Source:	Prestolite Electric Ltd - Greenford, London, UK
Date:	November 3, 2015
Bulletin No:	TSB4063 rev.1
Models:	M90R3538SE Starter motor
Subject:	PRODUCT CHANGE NOTICE

M90R3538SE STARTER BUILD CHANGE

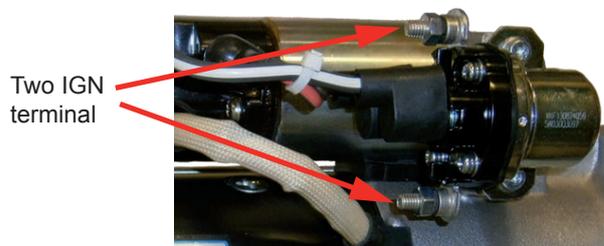
M90R3538SE will no longer be supplied with the earth lead to convert from 2 IGN terminal type to 1 IGN terminal type.

For 1 IGN terminal type use Prestolite part number M90R3556SE, replacing Mitsubishi M009T61471.

For 2 IGN terminal applications use M90R3538SE, replacing Mitsubishi M009T61473, M009T61474, M009T64791, M009T64972.
